DEVELOPMENT REVIEW COMMITTEE (DRC) COMMENT REPORT

**Project Name: LIPAO FLA 2 LLC / 1416 NE 4th Avenue
Commercial Building**

Case Number: R16009

**Request: Site Plan Level II Review: 1080sf Commercial
Building within 100 feet of Residential Property**

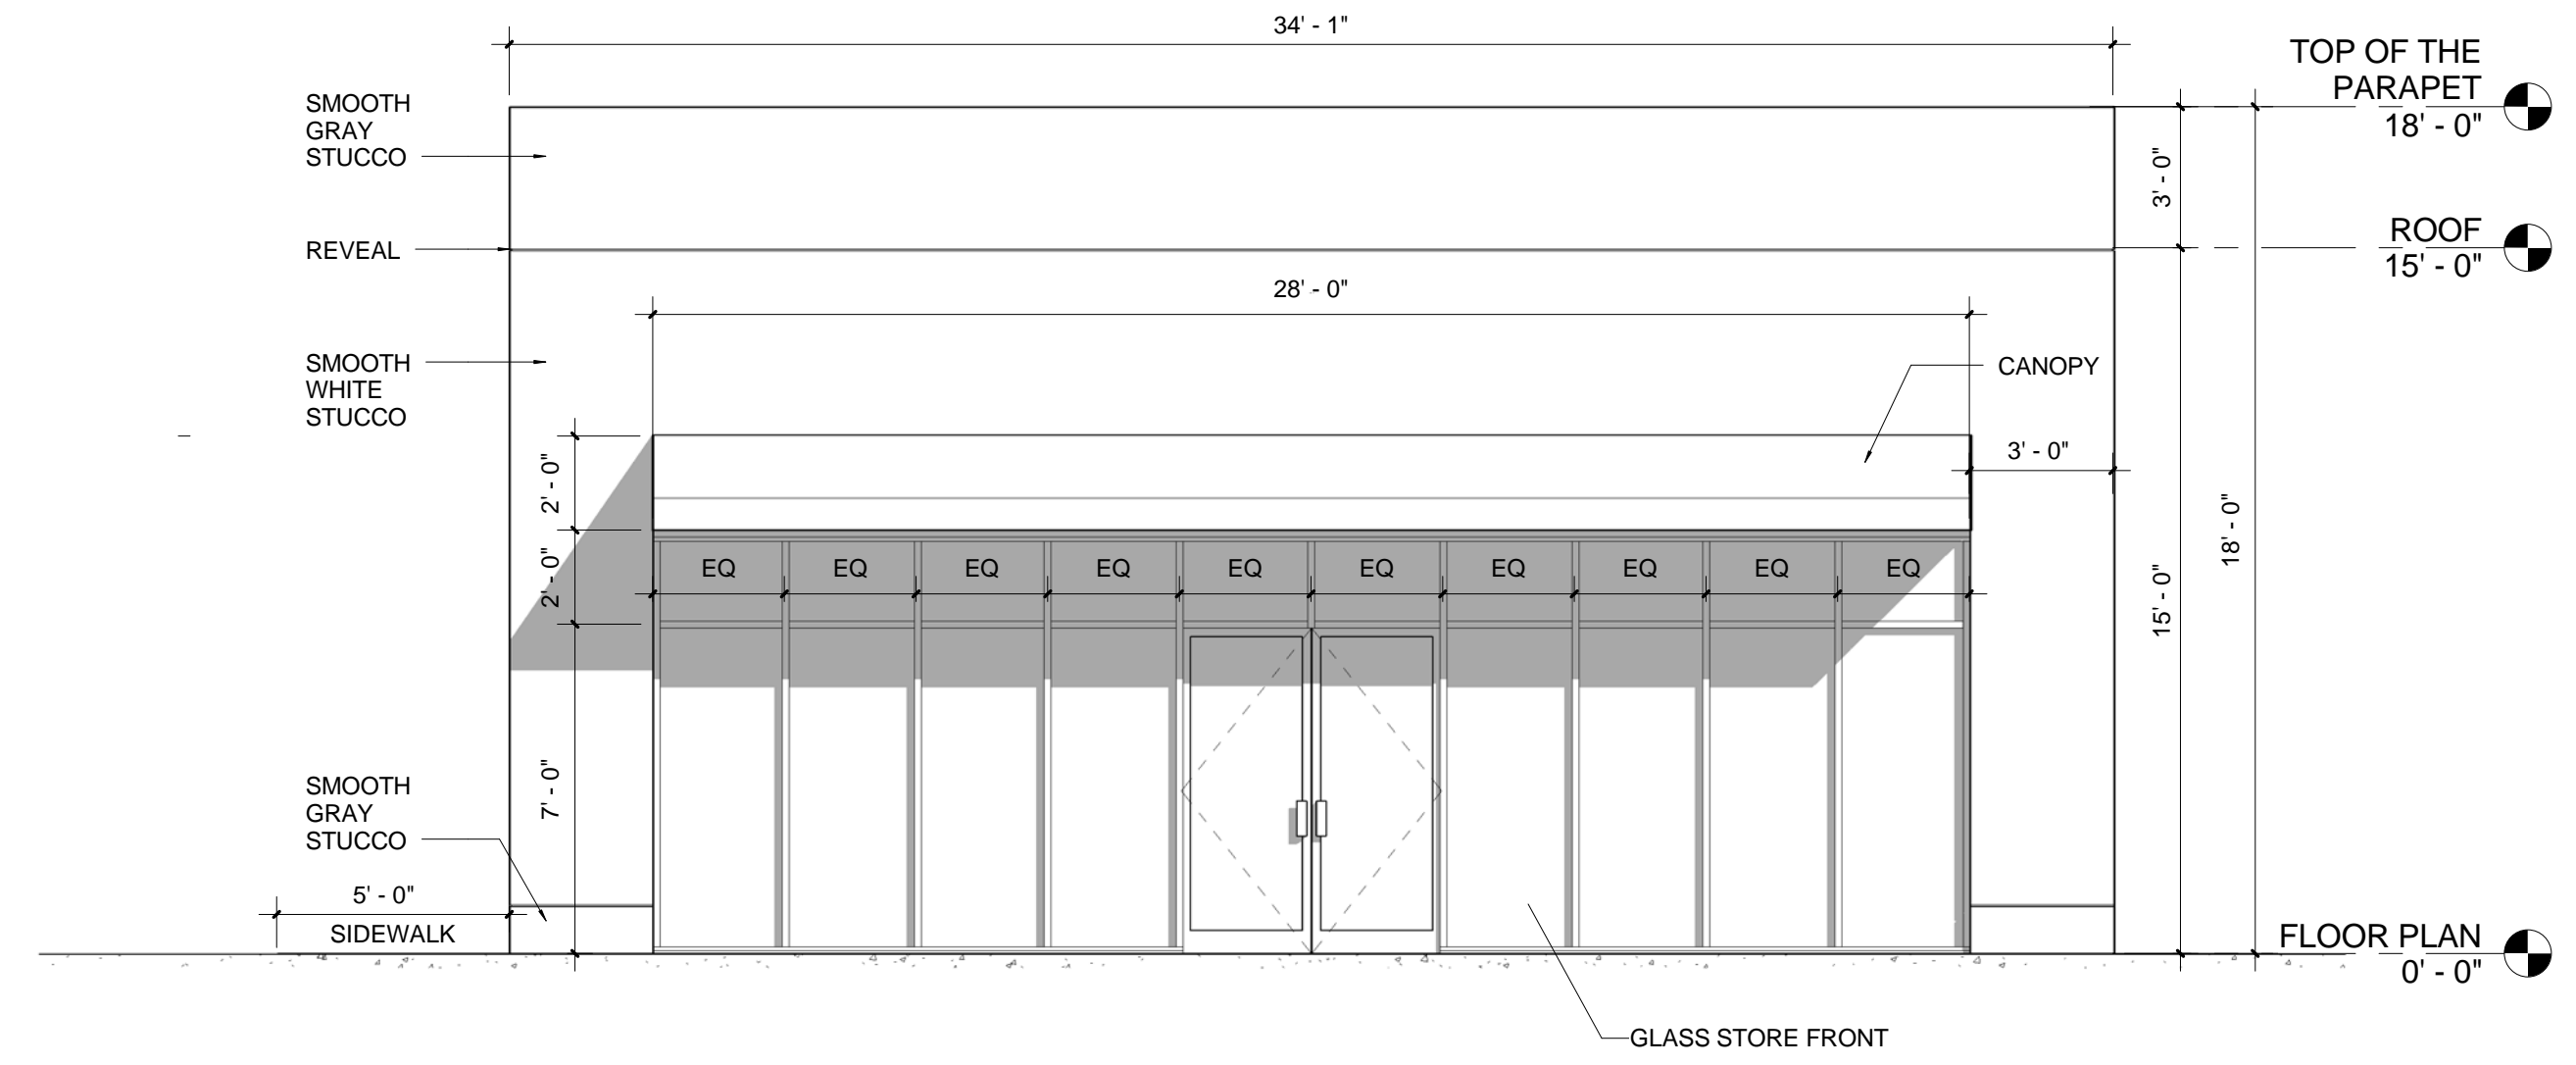
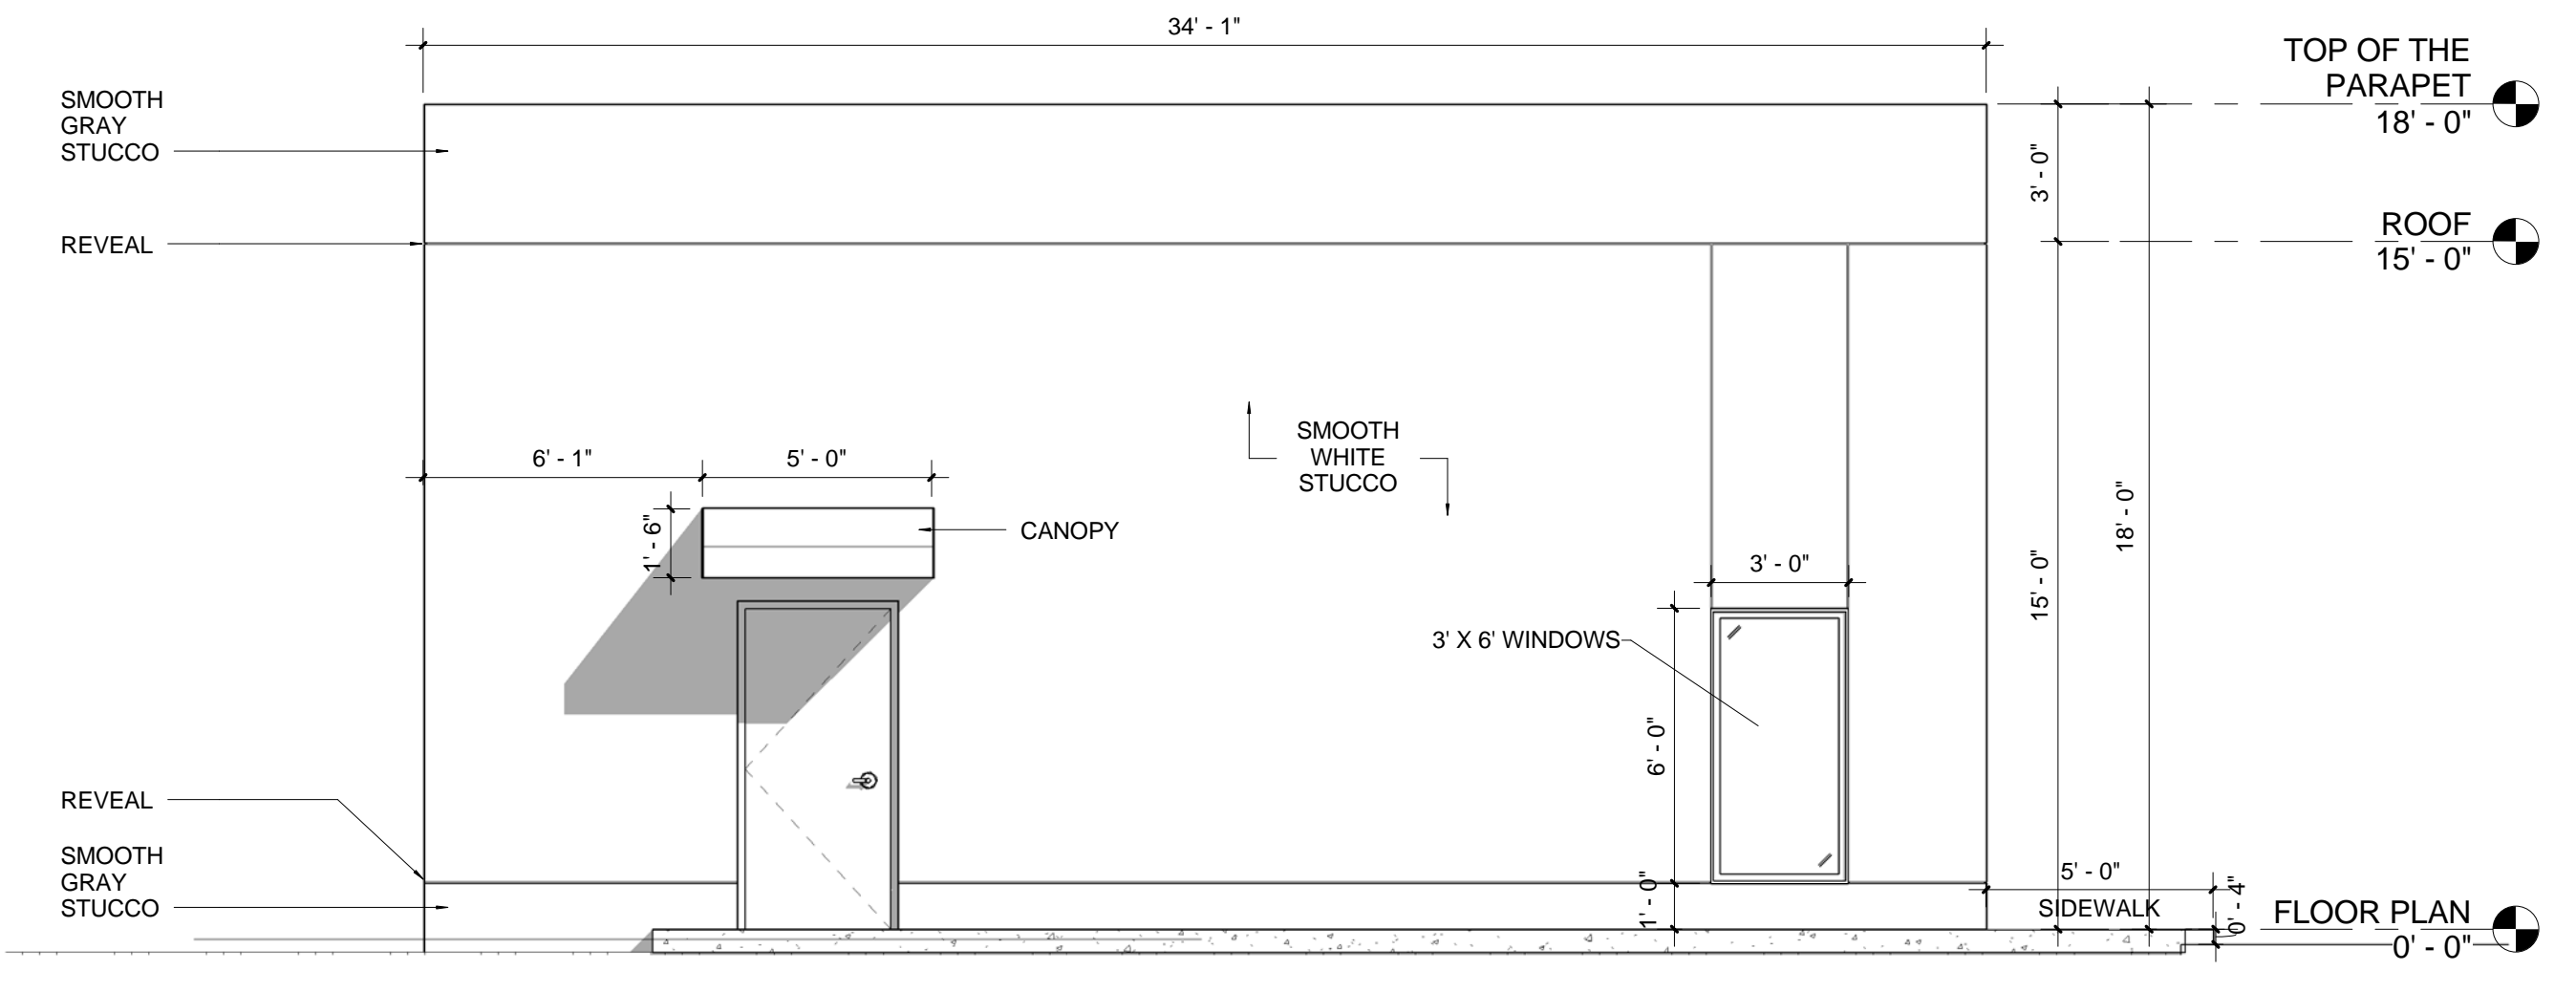
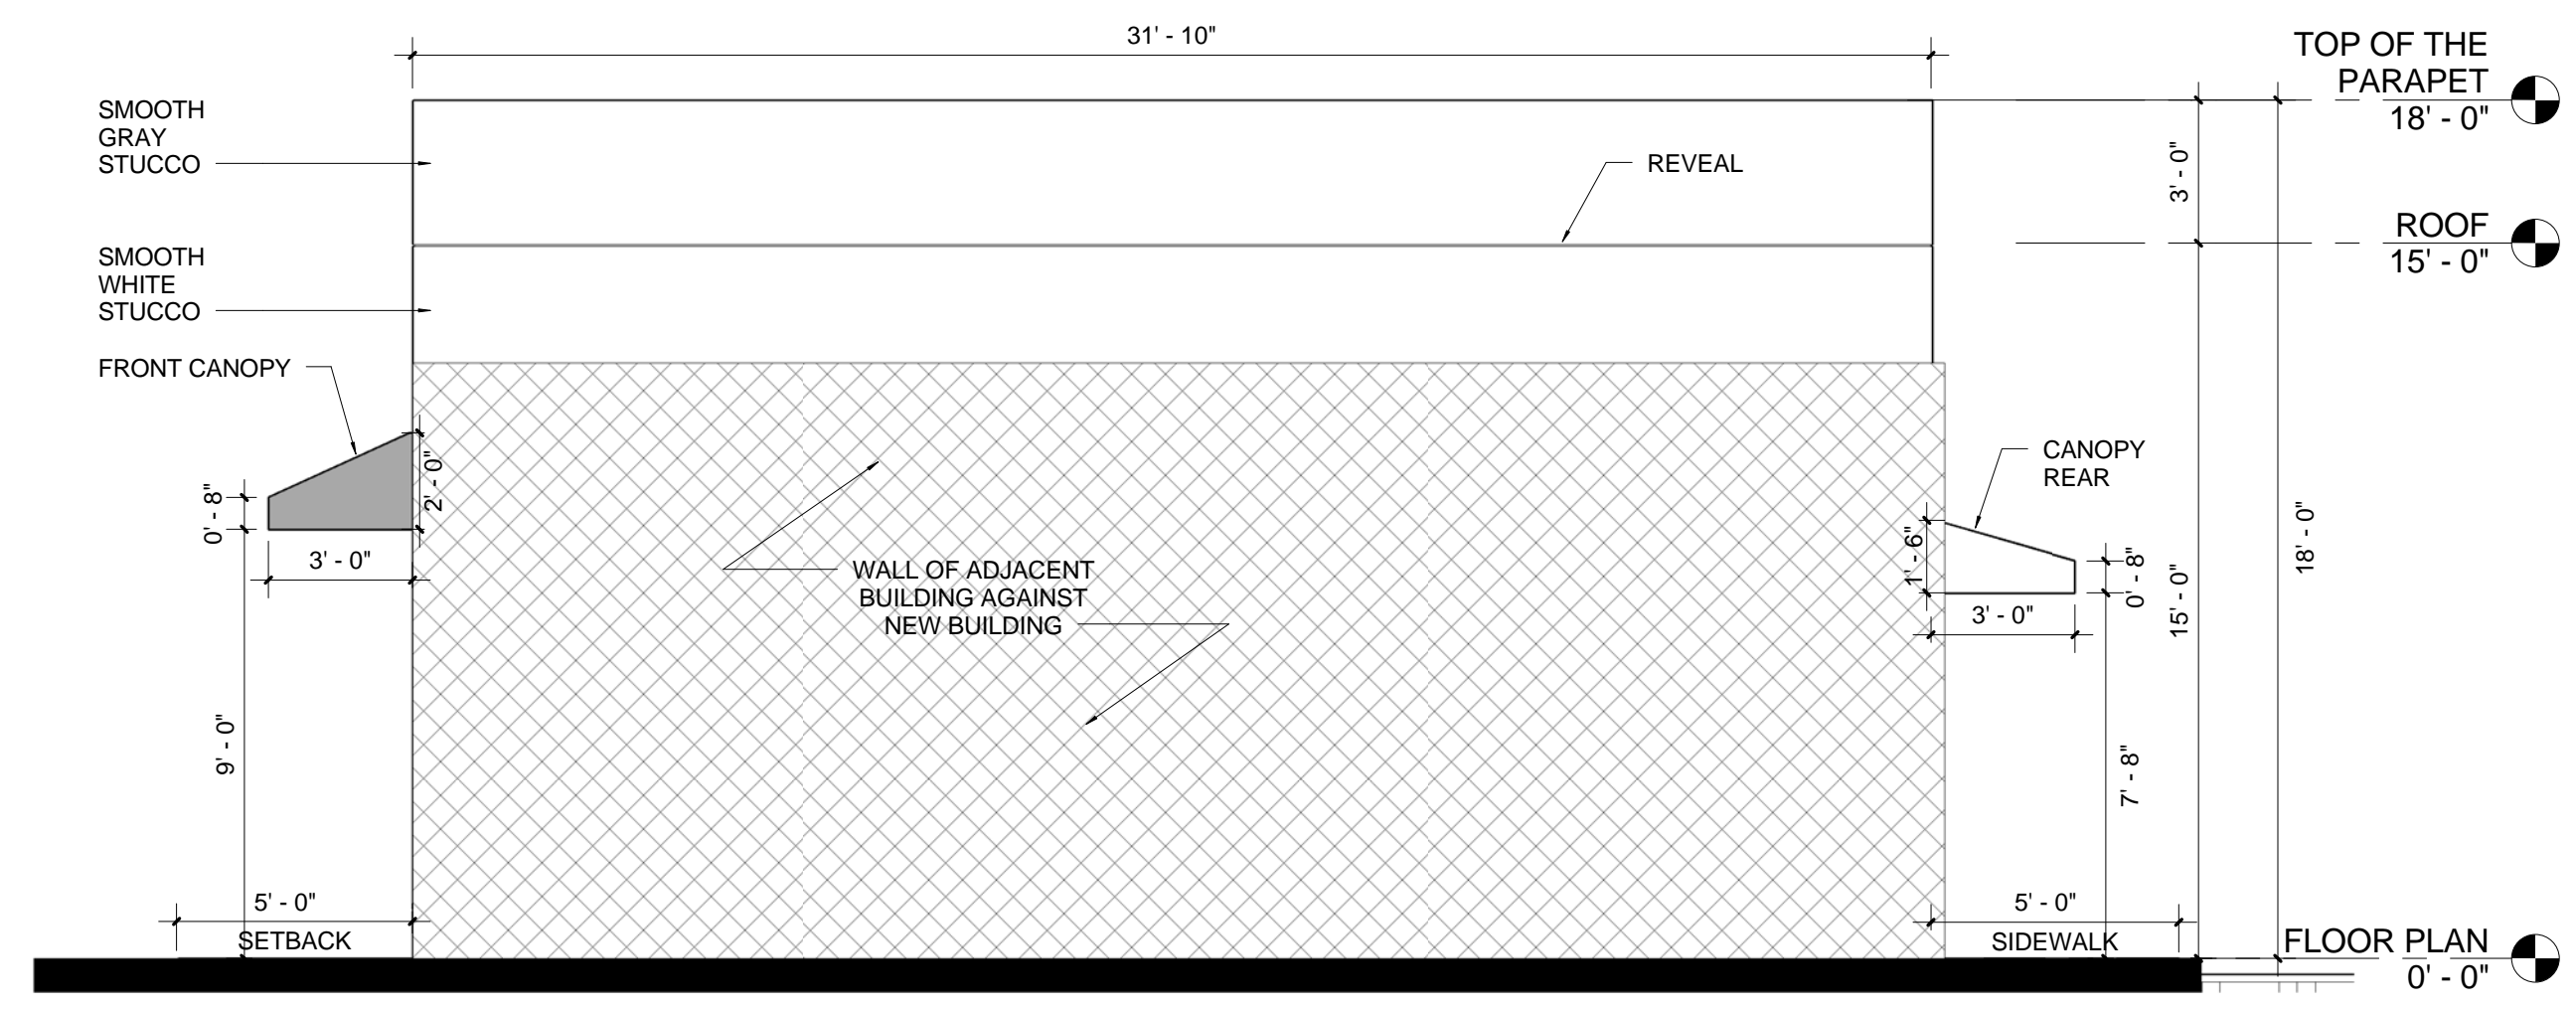
9. Sheet A-200: Show and label Right-of-Way boundary as appropriate on building Elevation drawings, to convey that the proposed front building canopy along N.E. 4th Avenue doesn't encroach into the Right-of-Way.
